**Amendments to the Drawings:**

Docket No.: BFC-106-C1

Date: June 26, 2006

FIG. 1

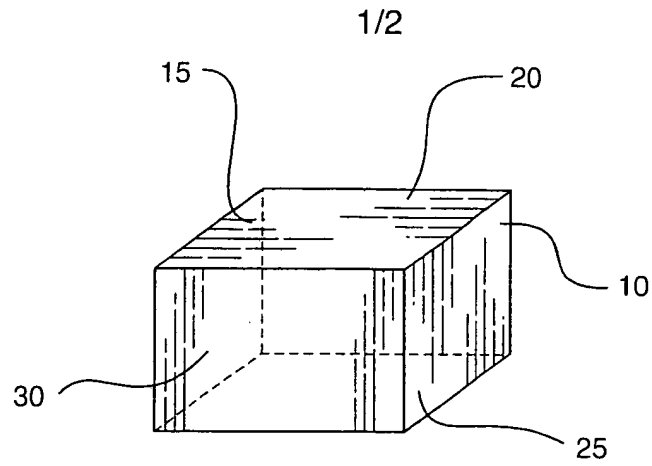
The drawings stand objected-to for the following reasons: reference characters "20" and "25" in Fig. 1, "47" in Figure 2 and "85" in Figure 4 are deemed not described in the specification. With respect to reference characters "20," "25" and "47," amendments to the specification have been made to describe the features highlighted by the reference characters. Support for the amendments is found in the drawings and throughout the specification.

FIG. 3

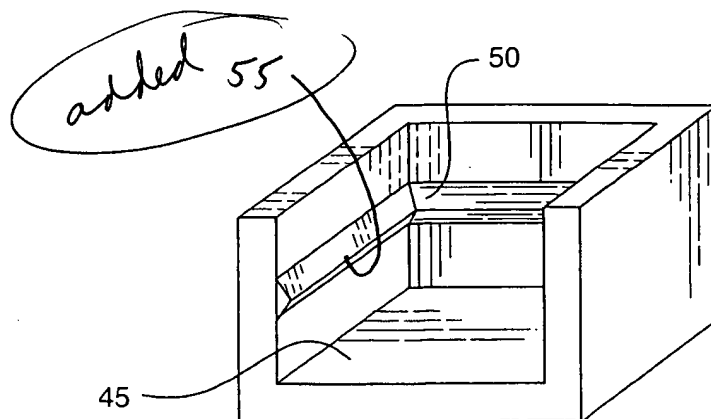
The attached sheets of drawings include changes to Figs. 3 and 4. These sheets, which include Figs. 1-6, replace the original sheets that include Figs. 1-6. In Fig. 3, previously omitted reference character 55 with an accompanying lead line has been added. In Fig. 4, reference character 85 has been changed to 55 to properly correspond with the description in the specification.

With respect to reference character "85," Figures 3 and 4 have been amended to change "85" to "55," which is the reference character that identifies the feature being described in the specification. Entry of the amended drawings is respectfully requested. The amendments to the specification and drawings render the objections to the drawings moot. Reconsideration and removal of the objections to the drawings are respectfully requested.
